GDA close-out for the AP1000 reactor

GDA Issue GI-AP1000-RP-01 Rev 0: Spent Fuel Pool – Criticality Safety Case

Assessment Report: ONR-NR-AR-16-019-AP1000
Revision A
March 2017

Figure 1: Overall spent fuel pool rack layout for the **AP1000** Generic Plant Design. [Taken from Figure 3 in Ref. 15].

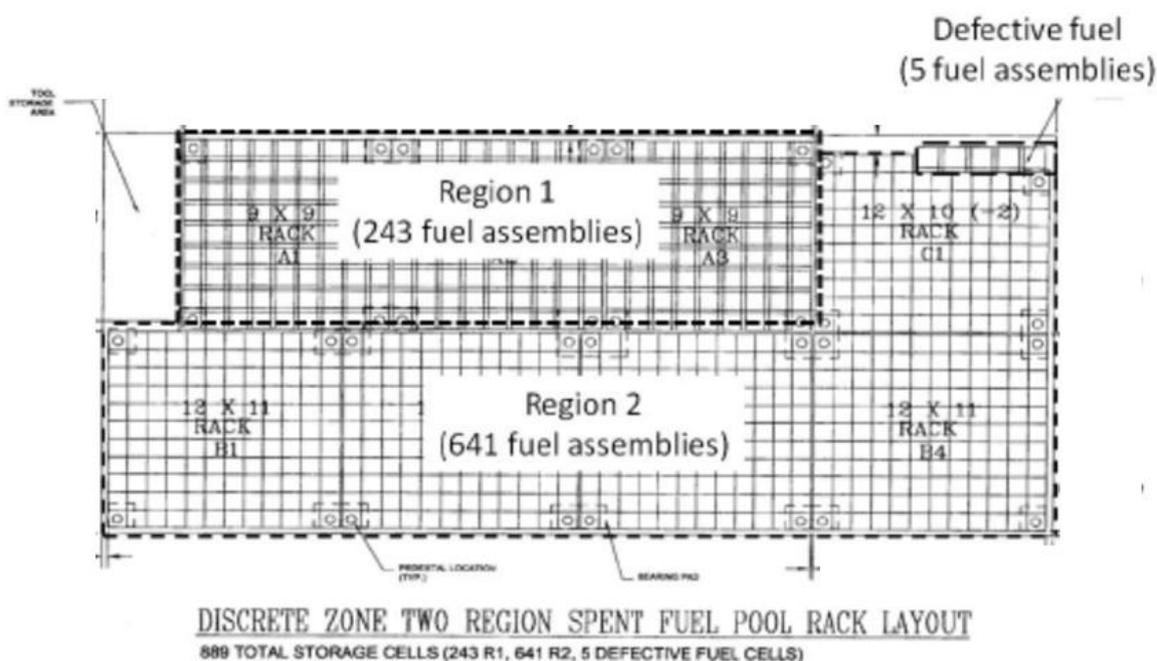
36. The original GDA Step 4 proposal for spent fuel pool management for the **AP1000** SFP utilised a two-region SFP design (referred to by Westinghouse in Ref. 11 as the '**AP1000** Generic Plant Design'). The generic **AP1000** SFP contains three Region 1 spent fuel storage rack modules and five Region 2 rack modules. The total storage capacity is 889 locations (or 732, while maintaining 157 cells 'empty' at any time to accommodate a full core offload). The design and layout of the racks is such that a fuel assembly cannot be inserted into a location other than a location designed to receive an assembly. Neutron-absorbing metal matrix composite panels (Metamic™, Holtec International*) are integral to the design, surrounding fuel assemblies in each cell. These neutron-absorbing panels form part of the hazard management strategy to prevent an uncontrolled neutron chain reaction, or criticality accident, in the SFP. An illustration of the layout is given in Figure 1.

Figure 2: Cross sections (typical) of Region 1 rack configuration (left) and Region 2 configuration (right). [Taken from Figures 4 and 5 of Ref. 15].

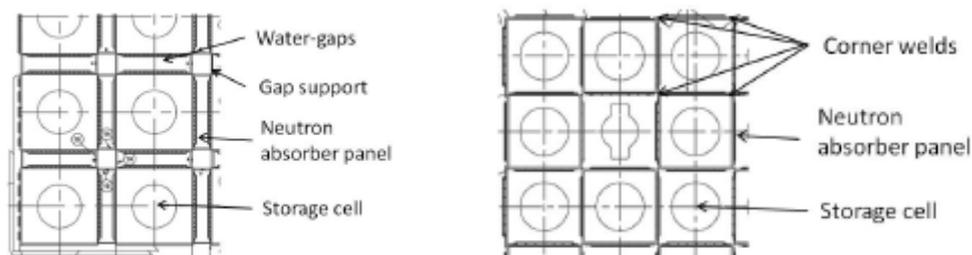
37. The Region 1 rack modules have a centre-to-centre spacing greater than that of the Region 2 rack modules, and the defective fuel assembly storage cells have a greater centre-to-centre spacing than Region 1 racks. The Region 1 racking houses two neutron-absorbing panels between locations, while the Region 2 racking houses one (illustrations are provided in Ref. 15 and repeated in Figure 2). These rack module configurations provide separation between adjacent fuel assemblies, with a neutron absorber to maintain a sub-critical array. The neutron absorber is made up of boron carbide in a metallic matrix.
